DRC-2009-007024

December 23, 2009

Re: White Mesa Uranium Mill – First Round of Interrogatories From Review of License Amendment Request and Environmental Report For Cell 4B

FIGURE 2.1-1

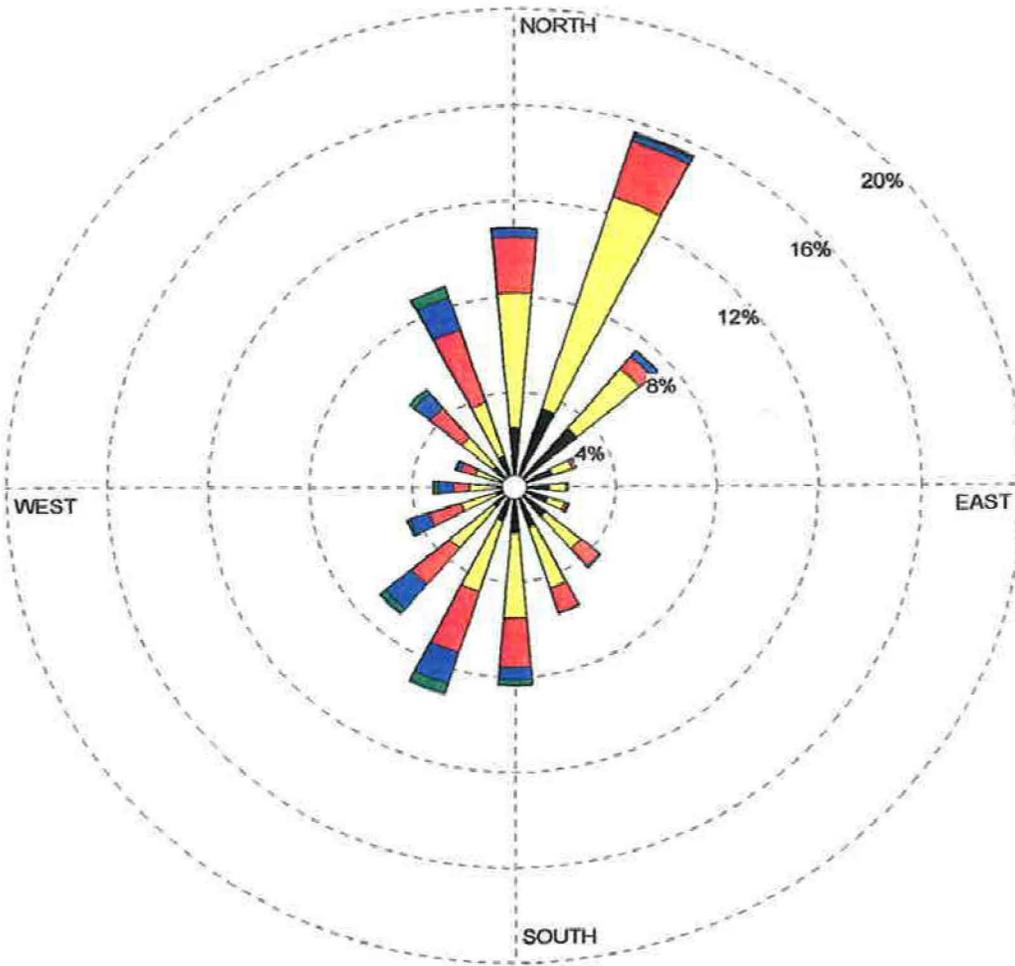
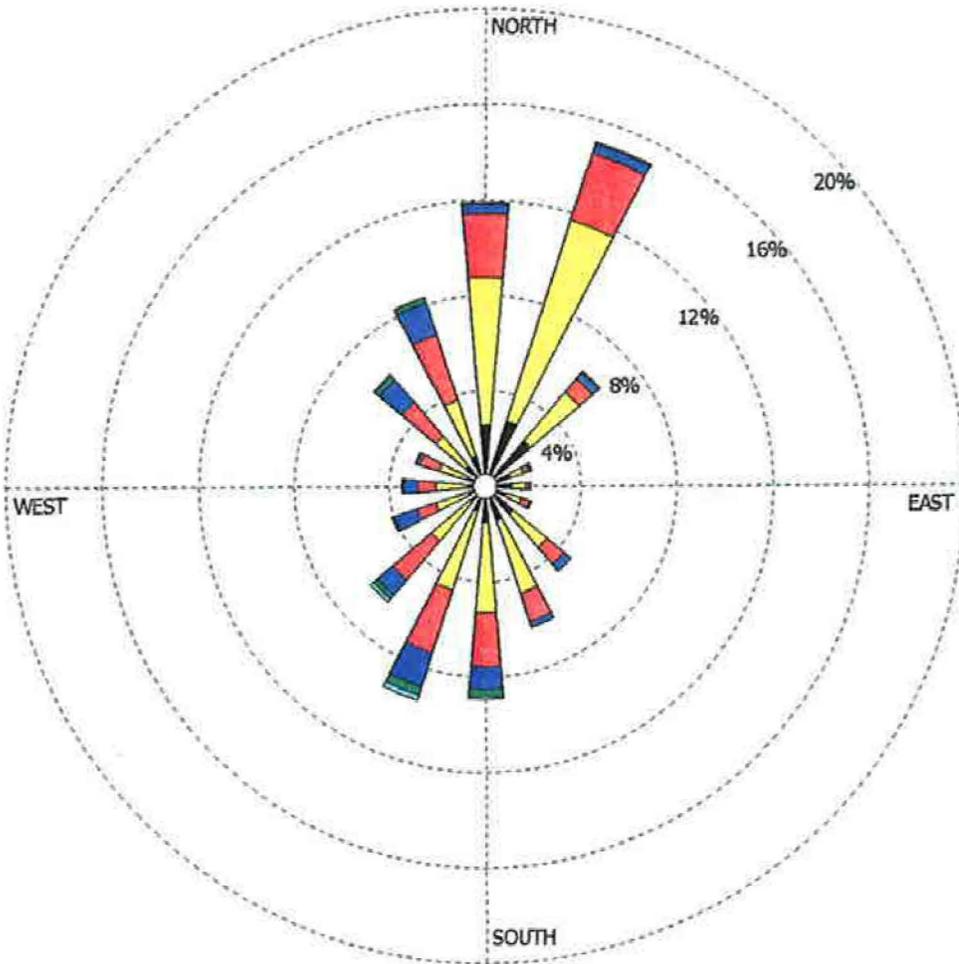
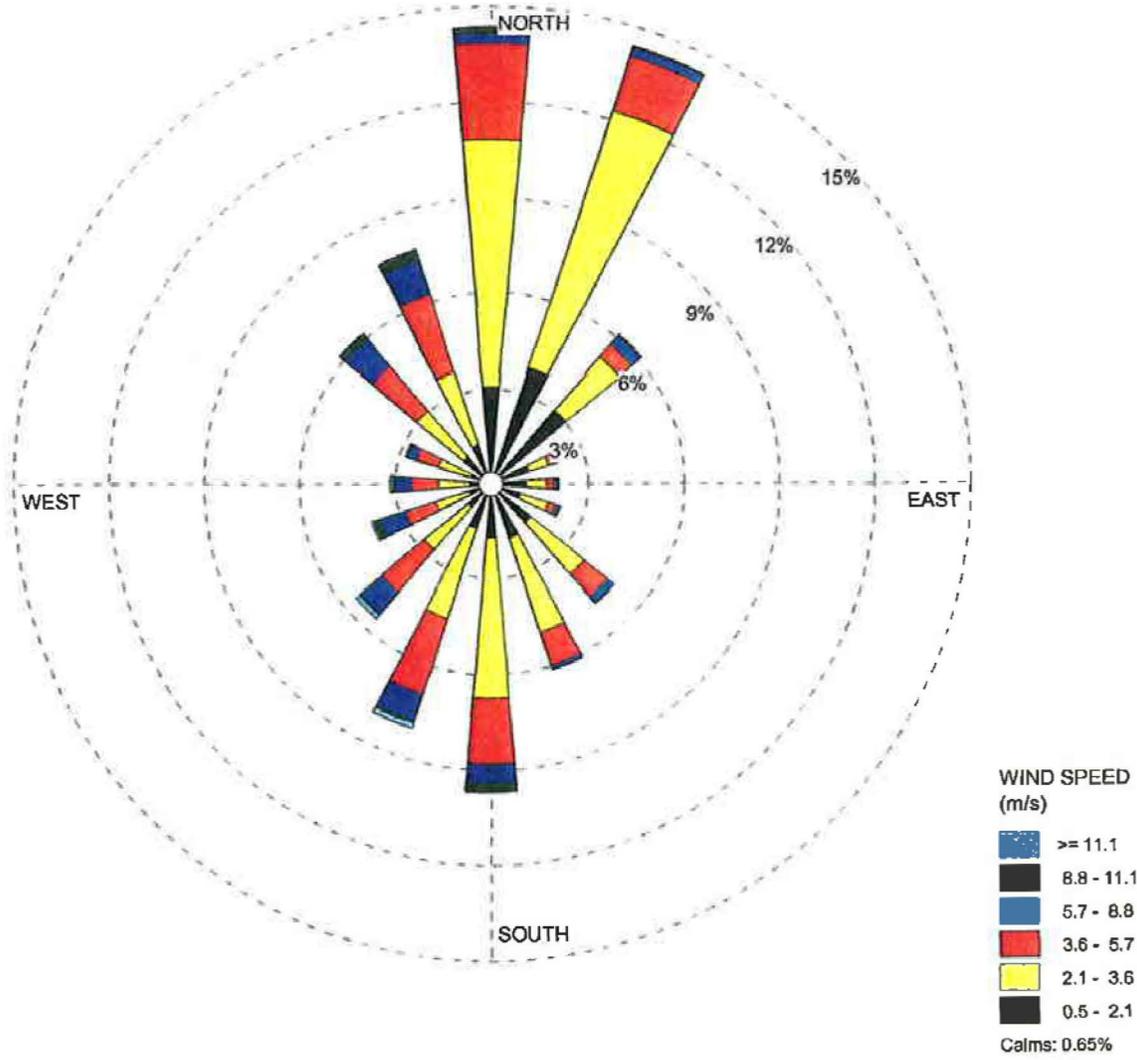
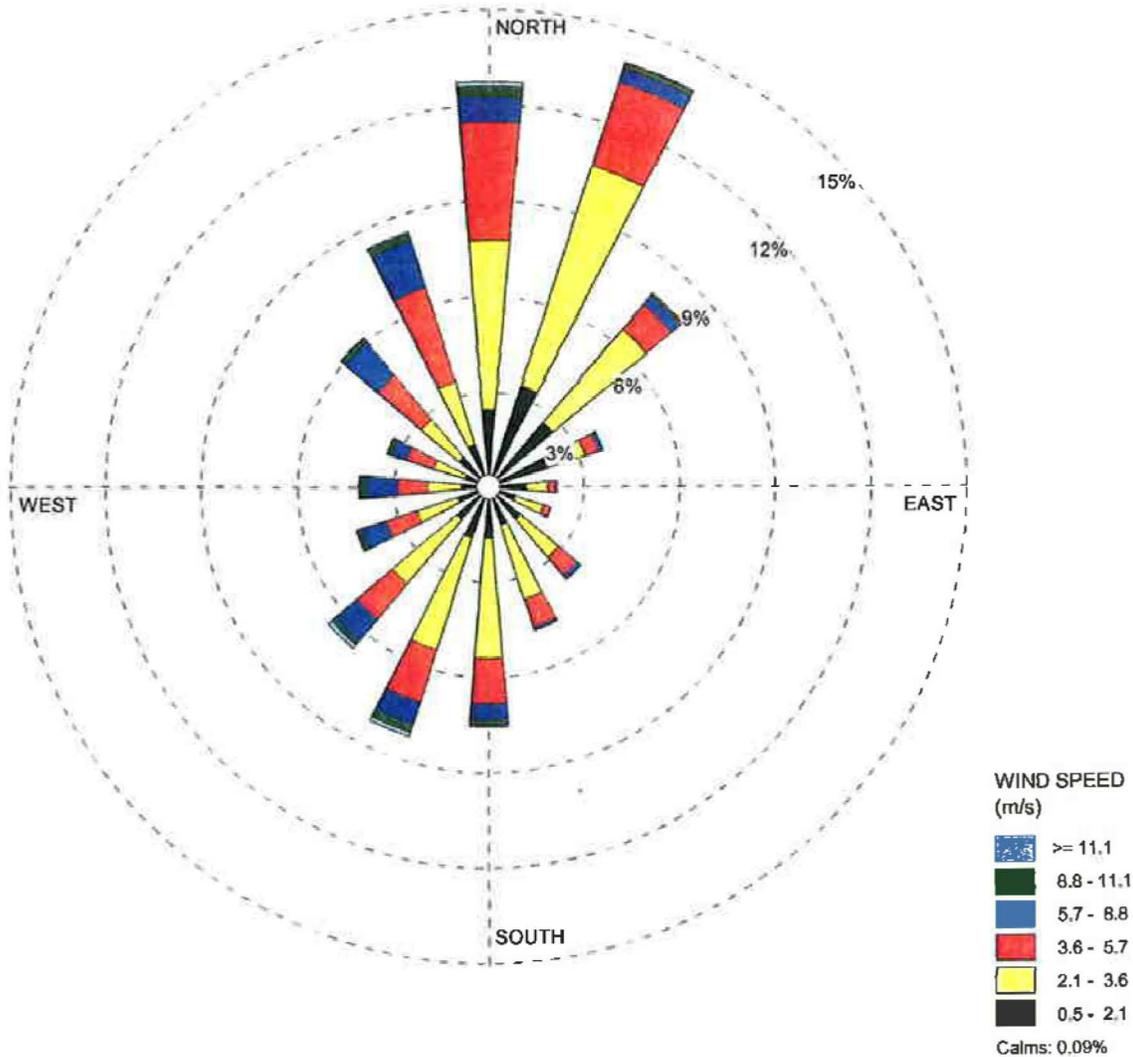
Figures 2.1-1 through 2.1-5 show the annual windrose for the site for each of 2004-2008. It is evident from those windroses that there have not been any significant changes in wind characteristics at the site during that period. The MILDOS-AREA evaluation performed for the site by SENES Consultants Ltd. in April 2008 in support of the Amendment Request (the 2008

Denison Mines (USA) Corp.			
REVISIONS	Project:	White Mesa Mill	
Date	By	County:	State: Utah
		Location:	
FIGURE 2.2.1-1			
GROUNDWATER APPROPRIATIONS WITHIN A			
5-MILE RADIUS OF THE WHITE MESA MILL			
Author:	unknown	Drafted By:	D.Siedt

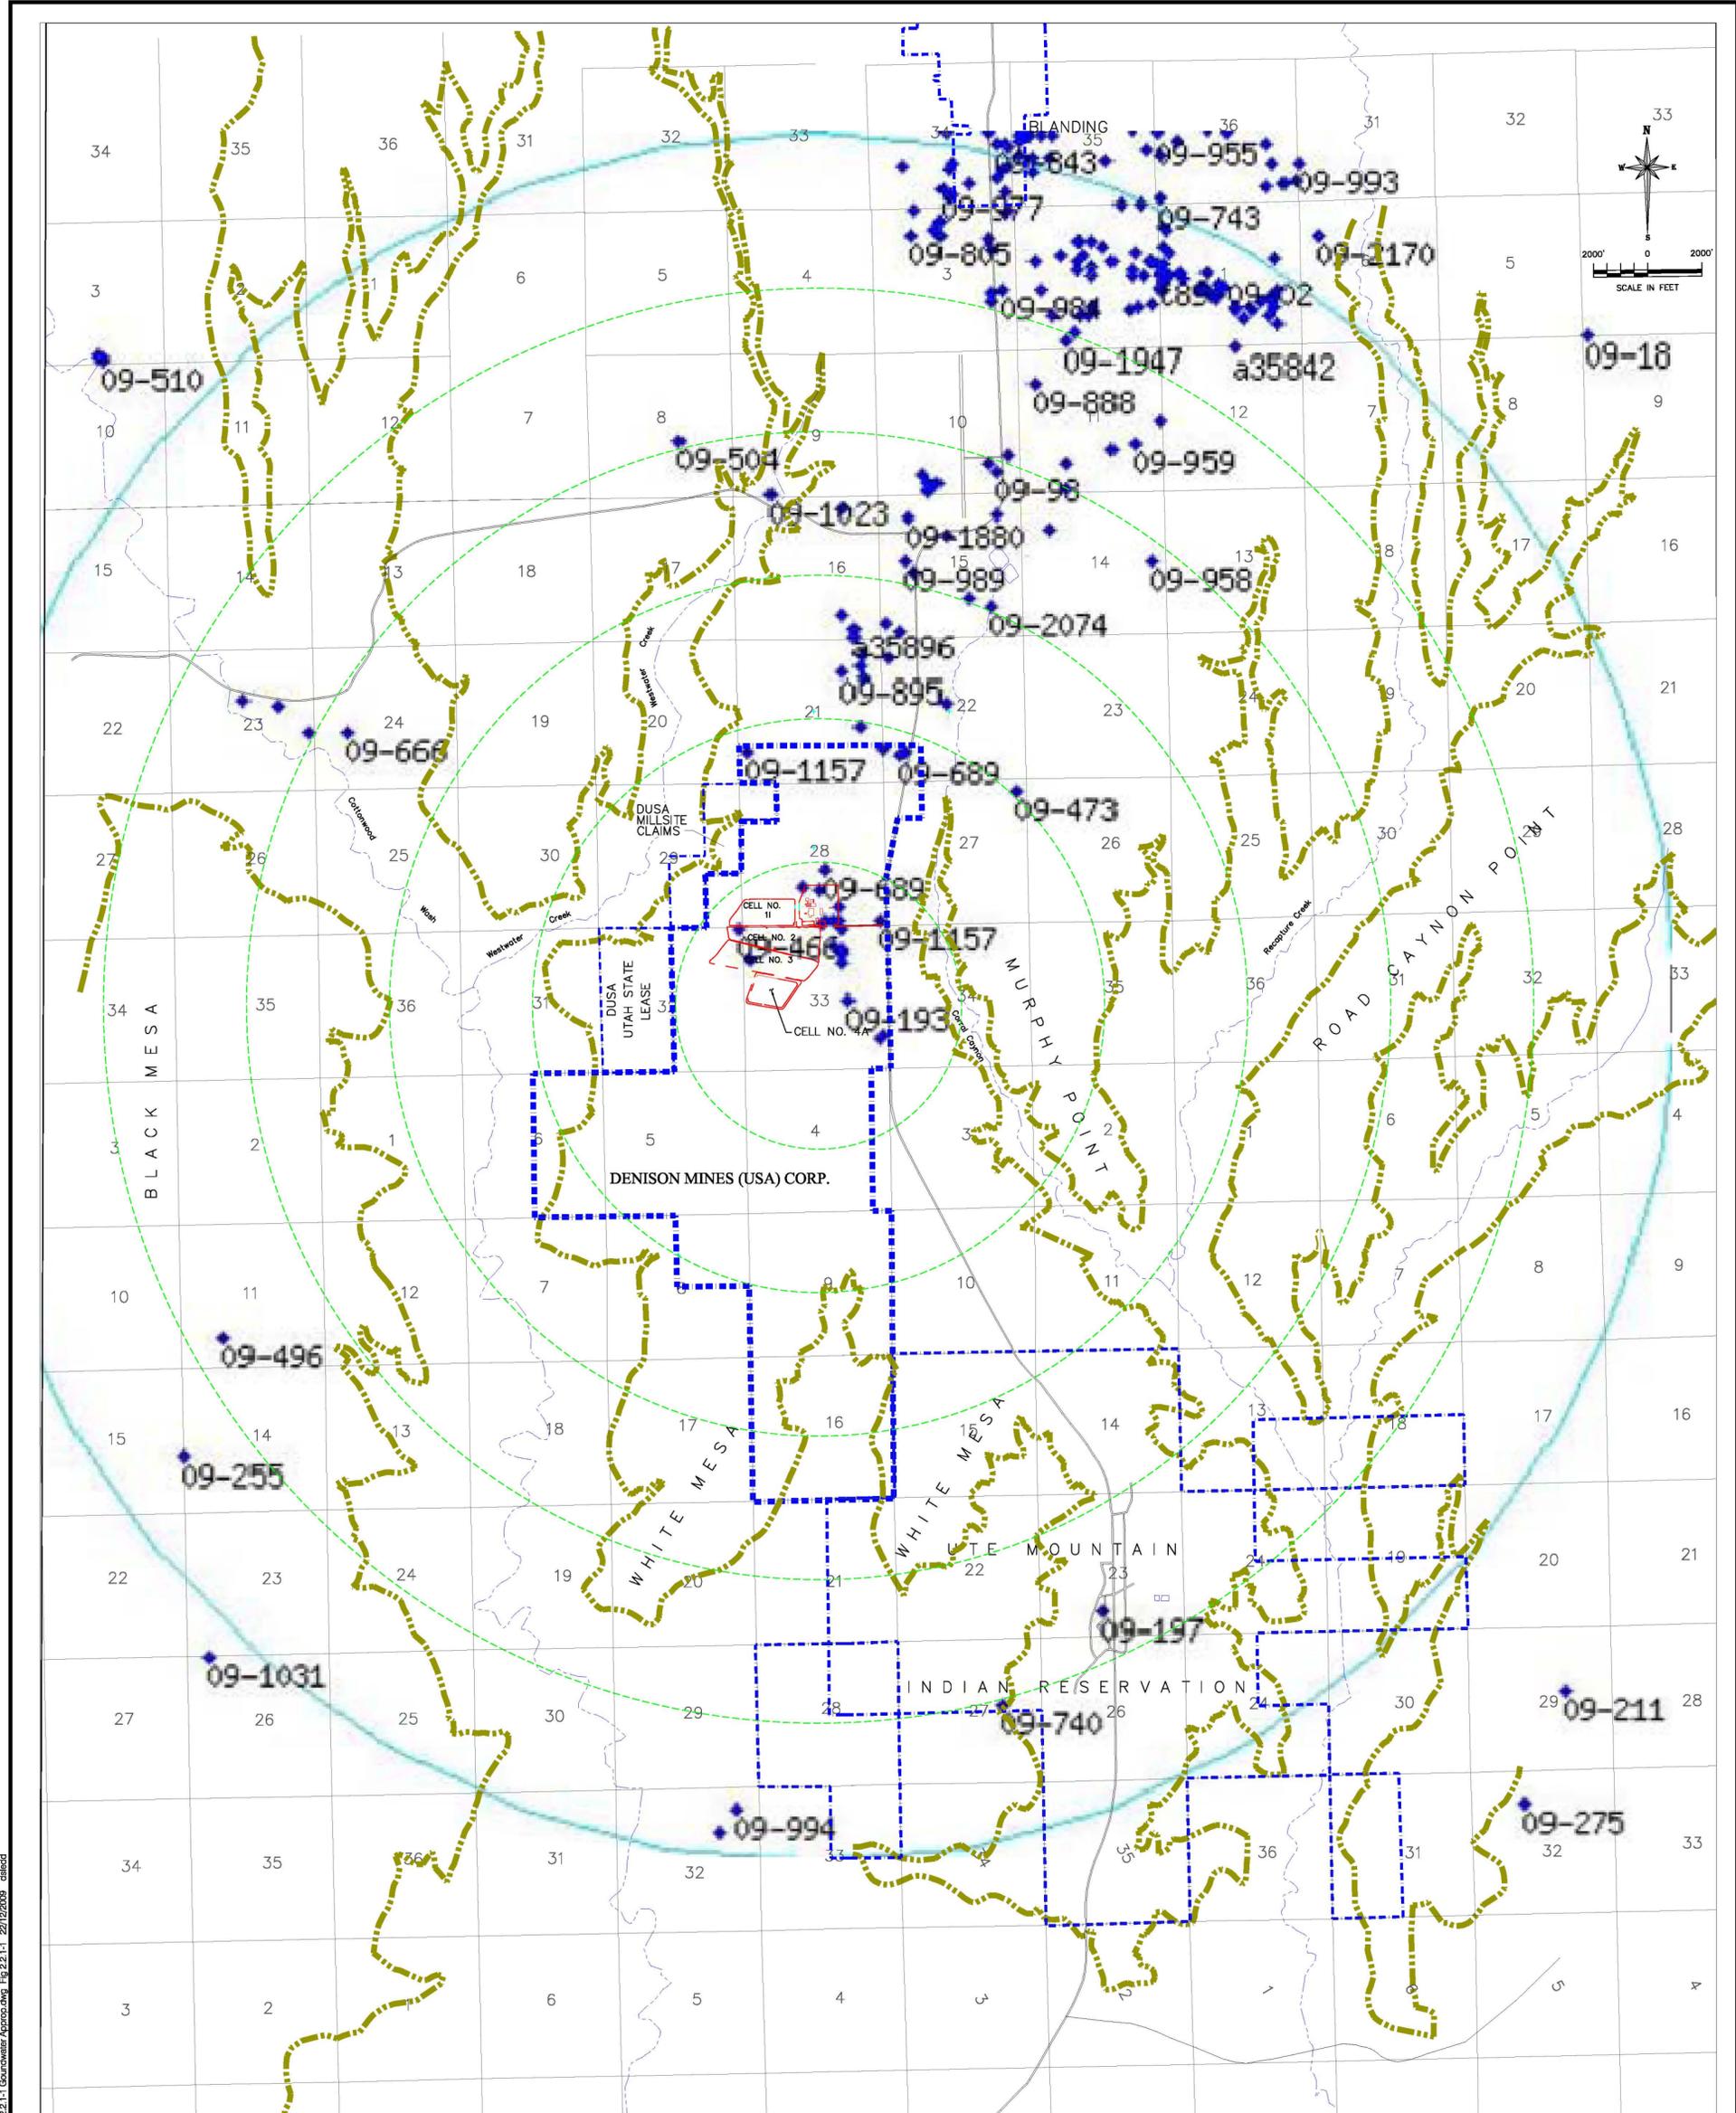
Two hundred sixty one groundwater appropriation applications, within a five-mile radius of the Mill site, are on file with the Utah State Engineer's office. A summary of the applications is presented in Table 2.2.1-1 and shown on Figure 2.2.1-1. The majority of the applications are by private individuals and for wells drawing small, intermittent quantities of water, less than eight gallons per minute (gpm), from the Burro Canyon formation. For the most part, these wells are located upgradient (north) of the Mill site. Domestic water, stock watering, and irrigation are listed as primary uses of the majority of the wells. It is important to note that no wells completed in the perched groundwater of the Burro Canyon formation exist directly downgradient of the site within the five-mile radius. Two water wells, which available data indicate are completed in the Entrada/Navajo sandstone (Clow, 1997), exist approximately 4.5 miles southeast of the site on the Ute Mountain Ute Reservation. These wells supply domestic water for the Ute Mountain Ute White Mesa Community, situated on the mesa along Highway 191 (see Figure 2.2.1-1). Data supplied by the Tribal Environmental Programs Office indicate that both wells are completed in the Entrada/Navajo sandstone, which is approximately 1,200 feet below the ground surface. Insufficient data are available to define the groundwater flow direction in the Entrada/Navajo sandstone in the vicinity of the Mill.
